LAW OFFICES OF GRACE & GRACE

Re: Navajo/Hidden Valley

In response to comments received from Supervisor Ed Lachterman comment email dated January 23, 2025, we offer the following updated responses:

COMPARISON PLAN OF TOWN OF YORKTOWN SANITARY SEWER DISTRICT & WESTCHESTER COUNTY PEEKSKILL SANITARY SEWER DISTRICT BOUNDARIES
 Town of Yorktown, Westchester County, New York
 January 27, 2025

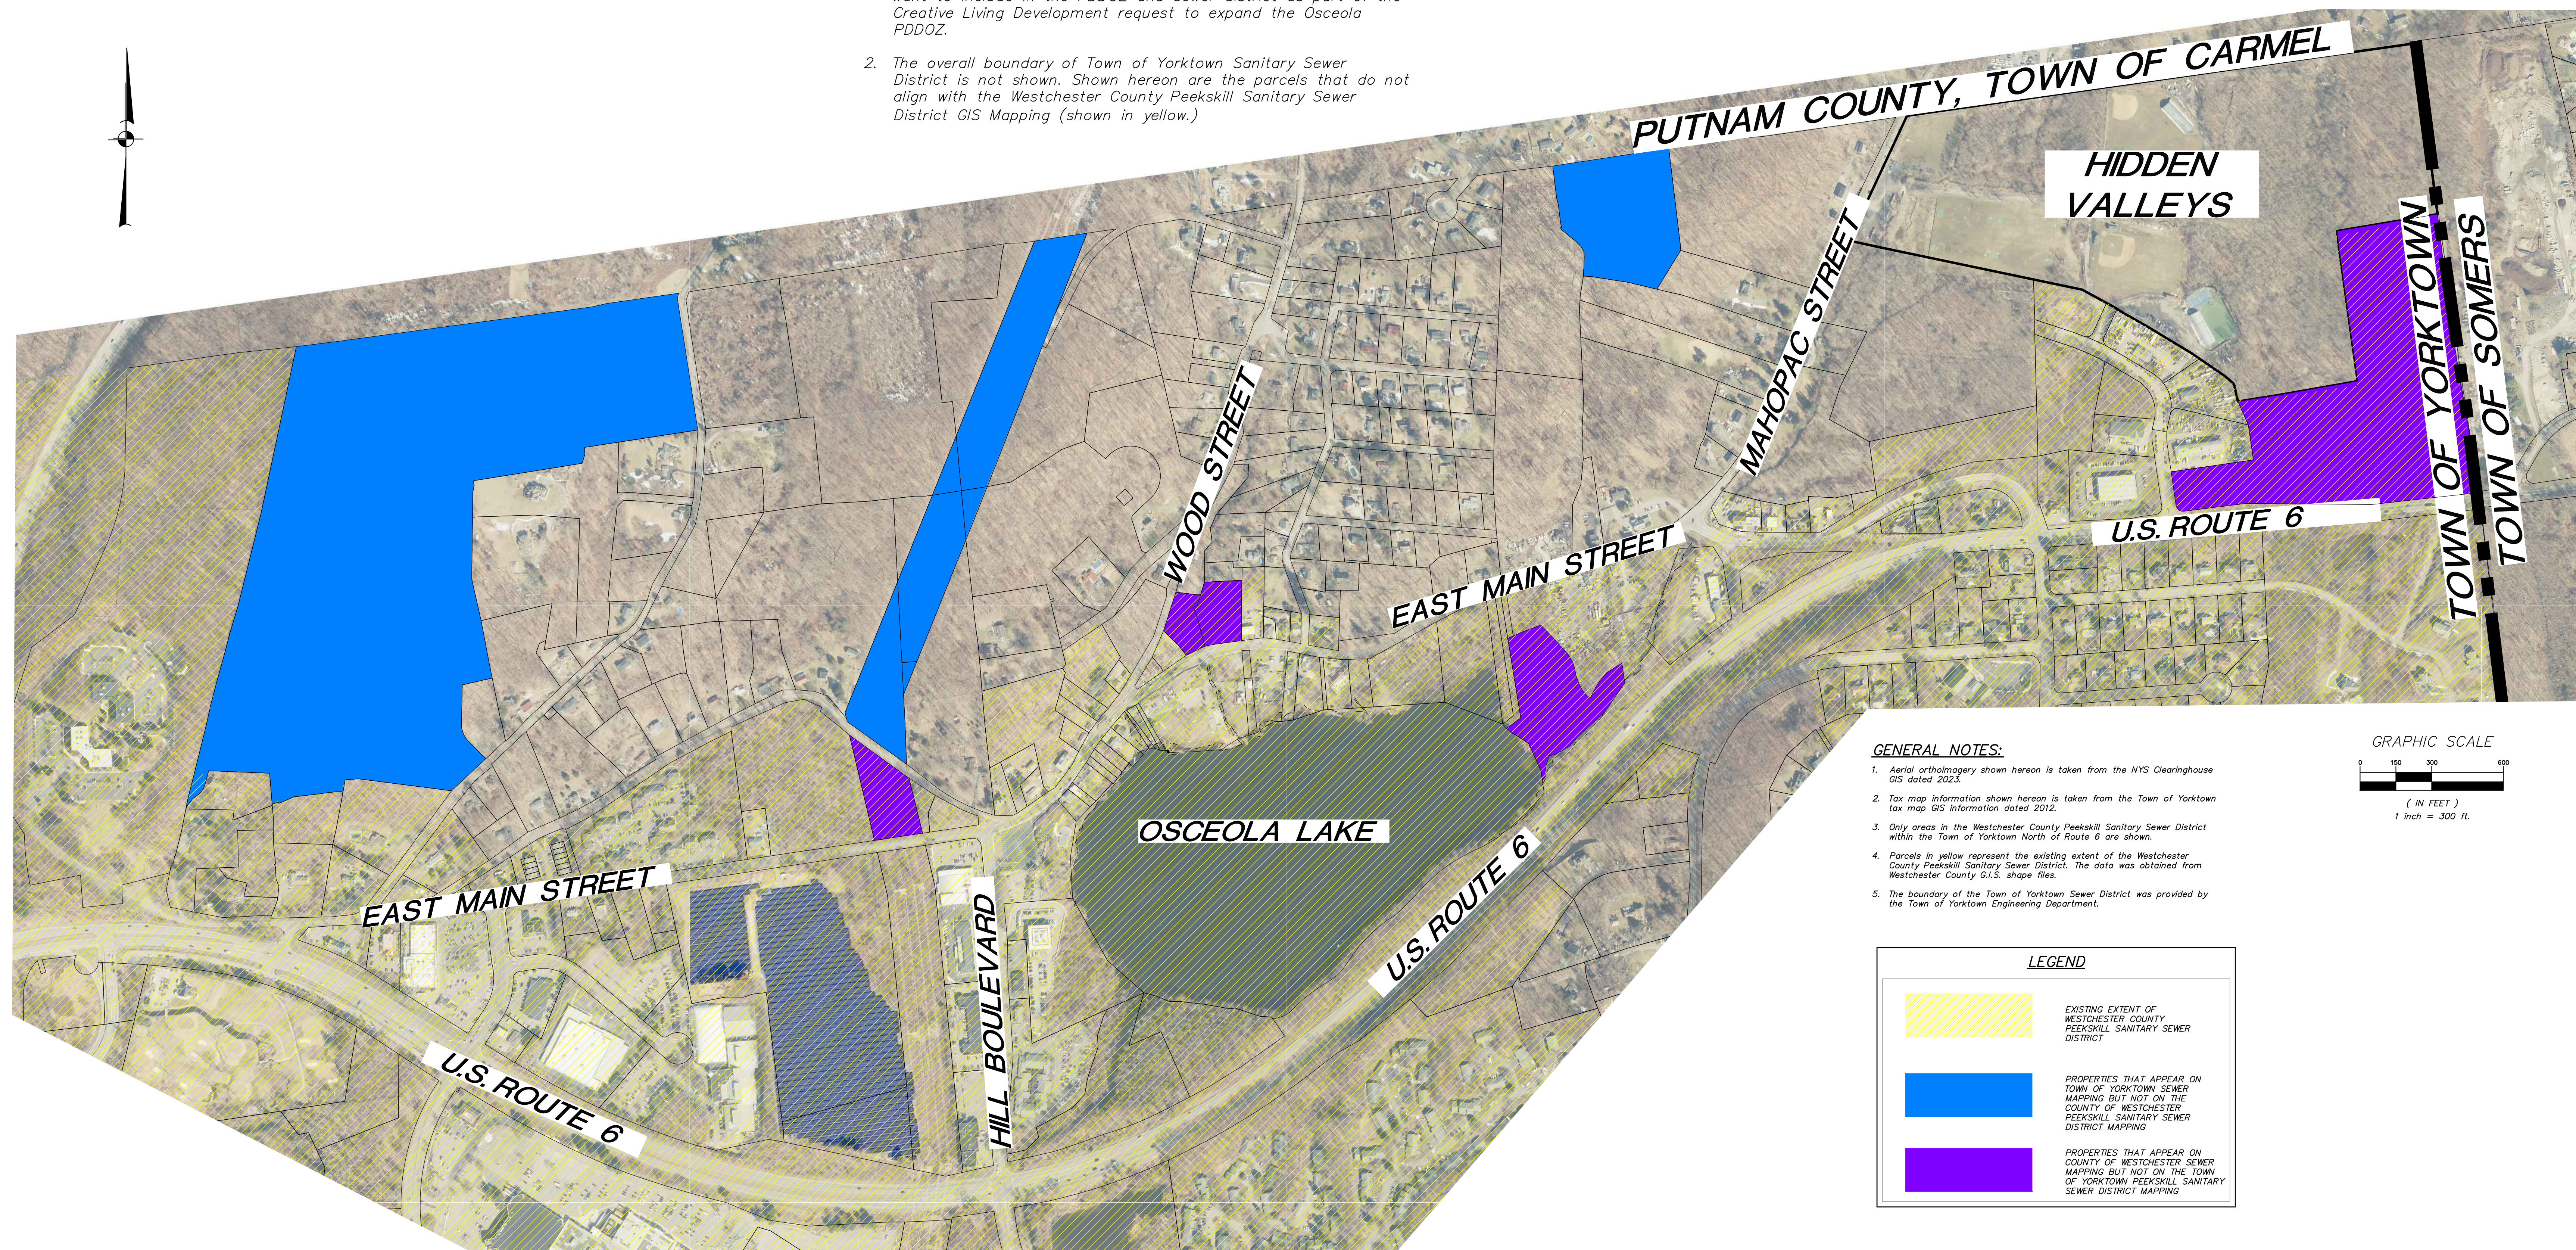
1. Provide a boundary map.

Enclosed please find a copy of the Osceola Lake PDDDOZ and Westchester County Peekskill Sewer District Expansion drawing prepared by this office. In addition, please also find enclosed the Comparison Plan of the Town of Yorktown Sewer District and the Peekskill Sanitary Sewer District Boundaries as it exists north of Route 6.

The requested information is illustrated on the enclosed drawing Comparison Plan of the Town of Yorktown Sewer District and the Peekskill Sanitary Sewer District Boundaries.

DRAWING: **CONCEPTUAL OFFSITE SEWER PLAN**

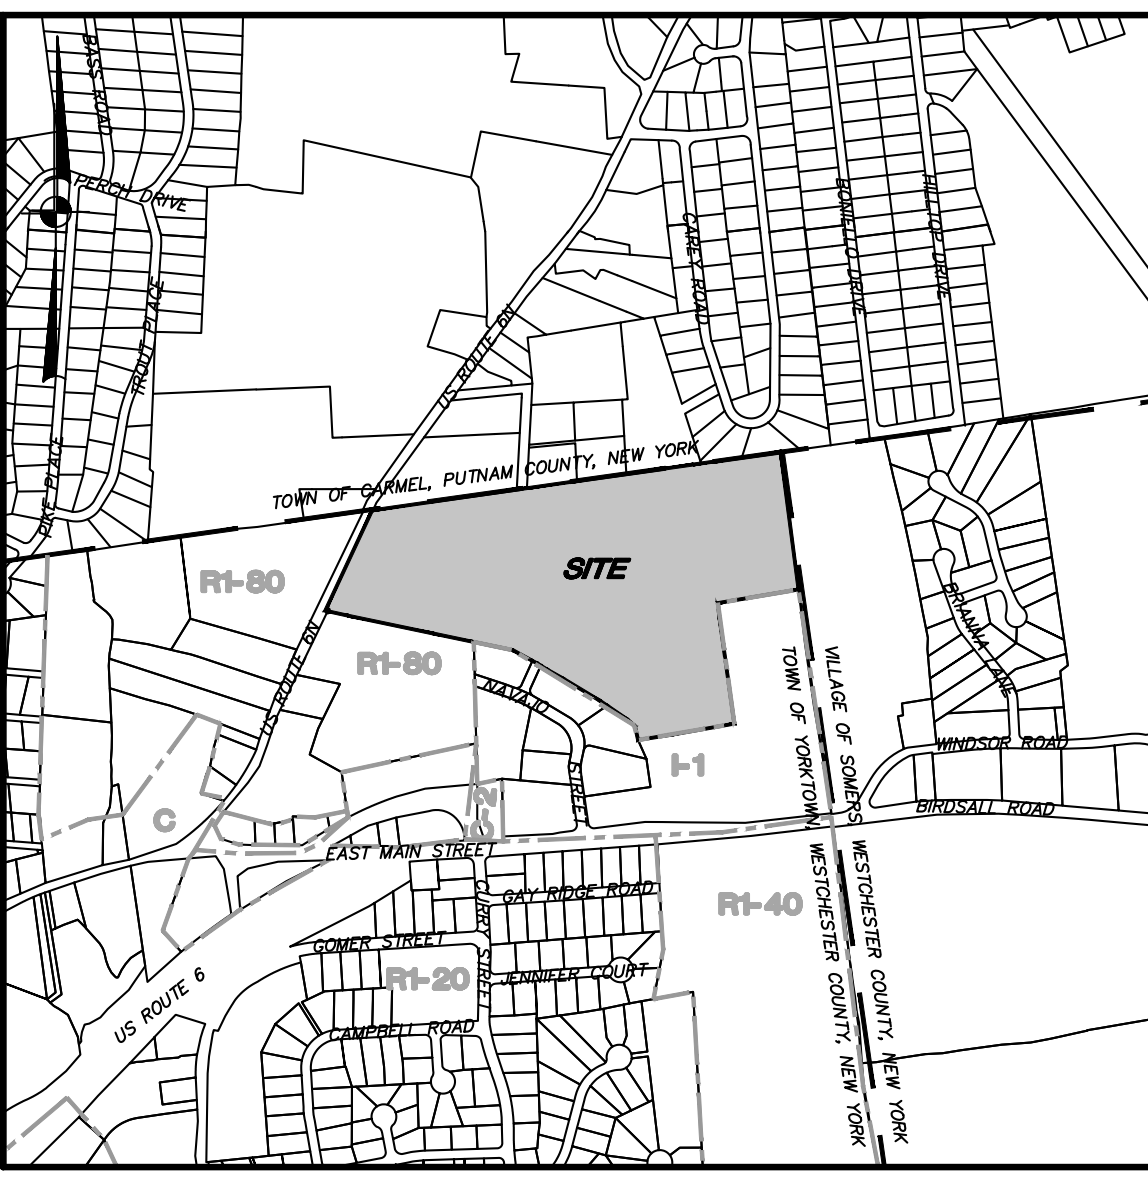
Comment:

Comment:

The S-1 drawing was revised on 1-27-25 as per the Lead Agency comments for the purpose of relocating the proposed pump stations therein to Town owned property as discussed with the Town's engineer. The location of the pump stations are designated in text and the Town property on which each sits clearly delineated.

The S-1 drawing indicates the location of manholes in the sewer extension. The manholes will contain incorporated ladder rungs as required by code or as determined by the Town's Engineering department during the future design review process of the proposed Hidden Valleys project.

Drawing S-1 has been revised and enclosed herewith and shows the proposed pump stations located on Town properties.
